HISTORIC AND DESIGN REVIEW COMMISSION

Agenda Item No: 16

HDRC CASE NO: 2016-166
ADDRESS: 915 BURLESON ST
LEGAL DESCRIPTION: NCB 1302 BLK 3 LOT 15
ZONING: R5 H
CITY COUNCIL DIST.: 2
DISTRICT: Dignowity Hill Historic District
APPLICANT: Victor Hernandez
OWNER: Victor Hernandez
TYPE OF WORK: Construction of a carport
REQUEST:

Front/Back

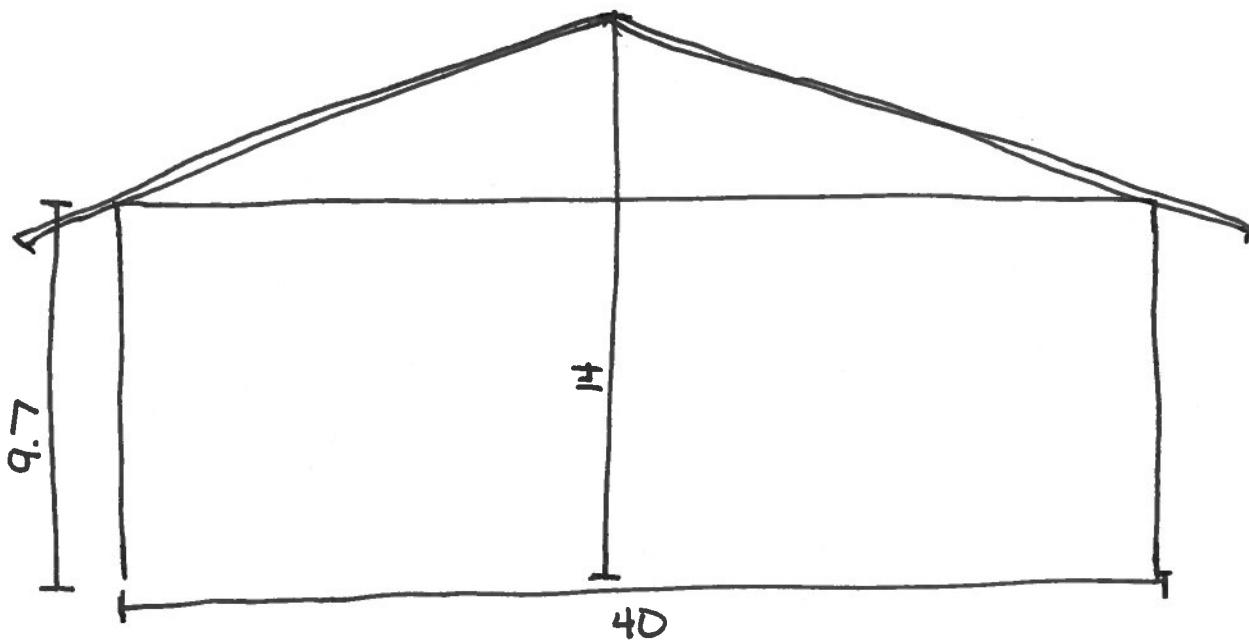
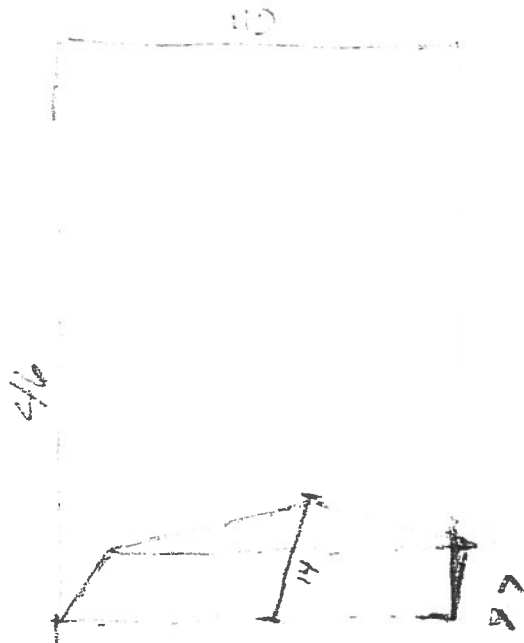
- a. According to the Guidelines for New Construction 5.A.i., new outbuildings should be visually subordinate to the principal historic structure in terms of their height, massing, and form. The proposed carport is not consistent with the Guidelines.

- b. According to the Guidelines for New Construction 5.A.ii., new outbuildings should be no larger in plan than 40 percent of the historic house on the property. The proposed carport has approximately the same footprint as the house and takes up the majority of the back yard space. This is not consistent with the Guidelines.

- c. According to the Guidelines for New Construction 5.A.iii., new outbuildings should relate to the period of construction as the historic house through the use of complementary materials. The proposed materials of steel framing and roofing are not compatible within the Dignowity Hill Historic District. Wood construction would be more appropriate.

- d. Because of its placement at the rear of the property, the proposed carport will not be readily visible from the street. While this is consistent with the Guidelines for New Construction. However, the overall scale and materials of the carport detract from the historic property and are not appropriate within the historic district.

Staff does not recommend approval based on findings a through d. Staff recommends that the carport be reduced in overall scale, lowered to no more 12 feet in height, and feature materials that are more compatible within the historic district.
